From: Randall Hicks <r@rthicksconsult.com>
Sent: Wednesday, May 4, 2016 12:20 PM
To: 'Gonzalez, Luis'; Bratcher, Mike, EMNRD
Cc: mike@rthicksconsult.com; 'Chris Northcutt'; Patterson, Heather, EMNRD; Billings, Bradford, EMNRD
Subject: RE: Clayton Williams Jenna

From: Randall Hicks [<mailto:r@rthicksconsult.com>]
Sent: Tuesday, May 03, 2016 3:18 PM
To: Bratcher, Mike, EMNRD
Cc: 'Gonzalez, Luis'; mike@rthicksconsult.com; 'Chris Northcutt'
Subject: Clayton Williams Jenna

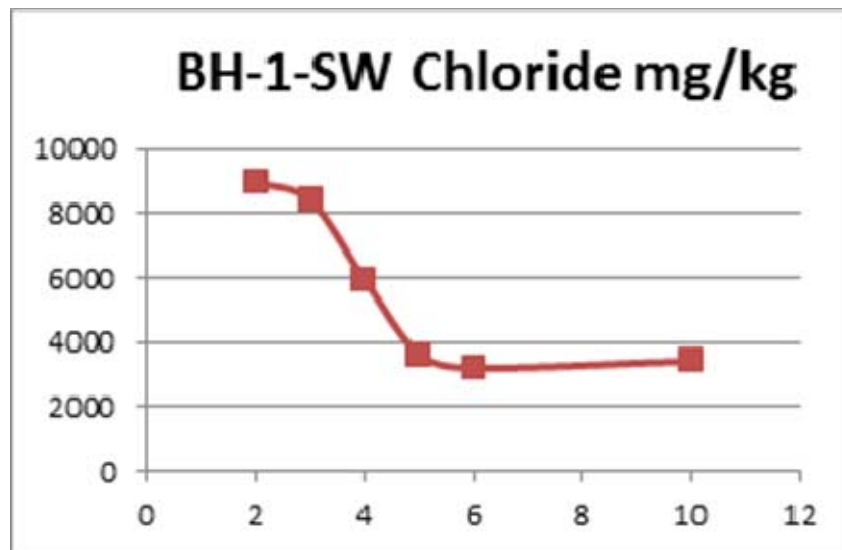
Thank you for the information. I notice that figure 6 is titled "Proposed Chloride Flushing Remedy". At this time, OCD does not have a recent remediation proposal for this site, and I believe the last one was denied. Please be advised, as we discussed, all work being done at the Jenna Com site is not per an OCD approved remediation proposal. My understanding is that one will be formulated based on a delineation of the entire site. Please let me know if this is incorrect.
